802.3dj D1.0
Comment Resolution - Electrical track
Adee Ran, Cisco

Introduction

Figure 176E-2—Components of a 200 Gb/s per lane AUI-C2M interface and insertion loss budget at 53.125 GHz

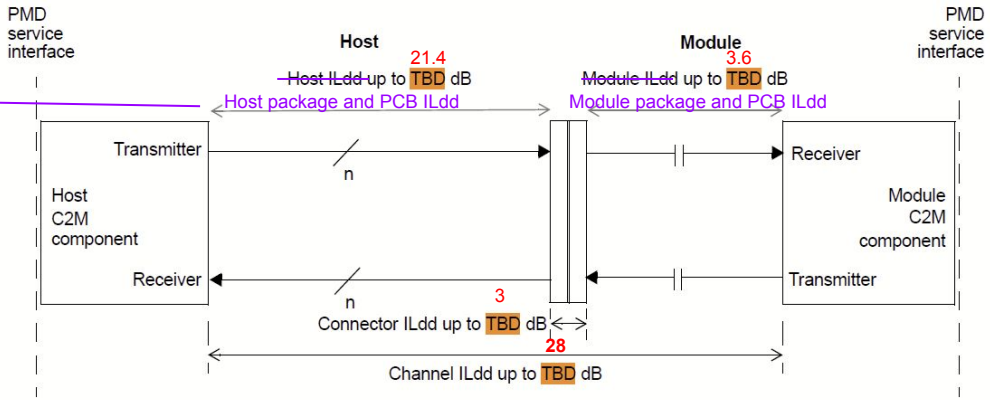
CI 176E SC 176E.4.1 P632 L6 # 73

The IL_dd for AUI C2M channel is a TBD

The referenced presentation is https://www.ieee802.org/3/dj/public/24_01/lusted_3dj_03_2401.pdf. The comment is against 176E.4.1 (Recommended channel characteristics/Insertion loss), which has an equation for the ILdd limit. The suggested remedy does not address the equation. The proposed value for this TBD (Channel ILdd) is **33 dB**. Comment #134 suggests **28 dB** for the same TBD.
